Technical Information Bulletin

SUBJECT ⟶ **PS8050 220vac Jumper Installation**

APPLIES TO: **PS8050** MODIFICATION SCHEDULE: **As Necessary** **DOCUMENT NO: 20433**

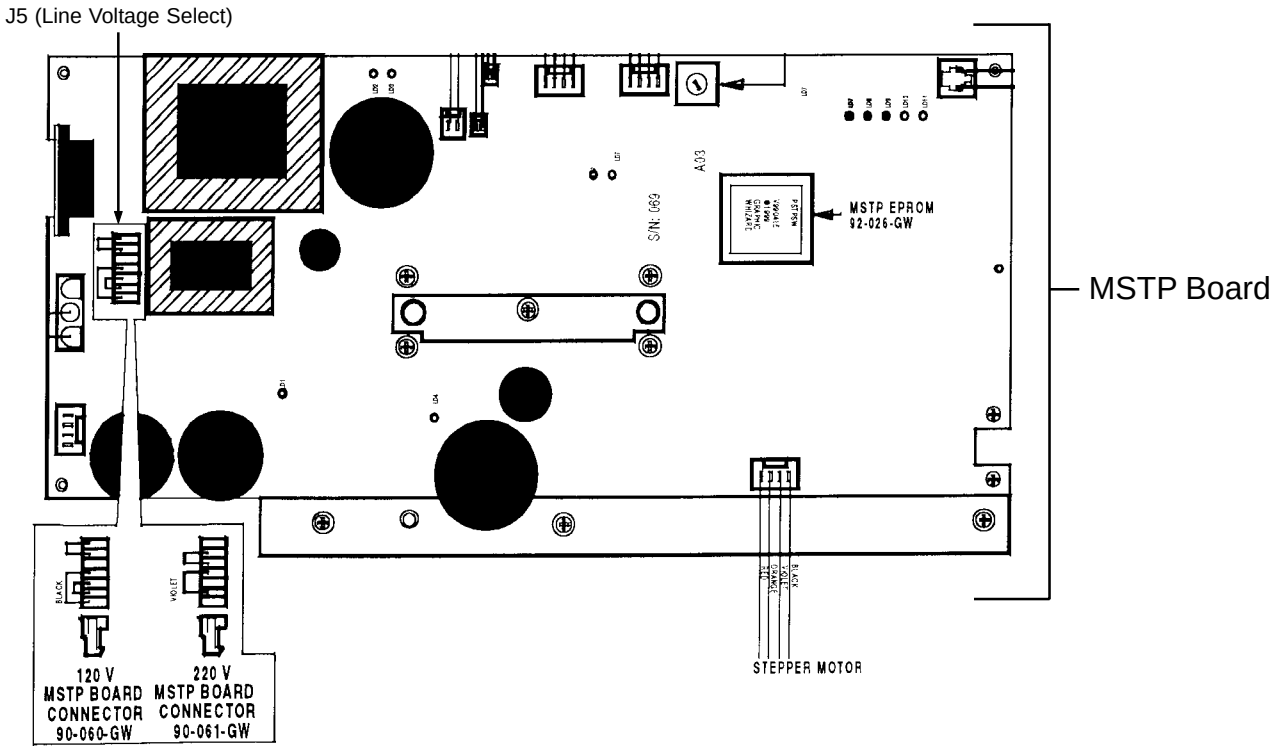
Summary: Since the PS8050 ships as a 110vac unit, machines installed in a 220vac environment have to be modified. This can be done easily using the extra 220vac jumper included with every unit.

1. Remove the operator-side cover.
2. Locate J5 (Line Voltage Select) on the MSTP board.
3. Replace the 110vac jumper with the 220vac jumper.
4. Reinstall cover.
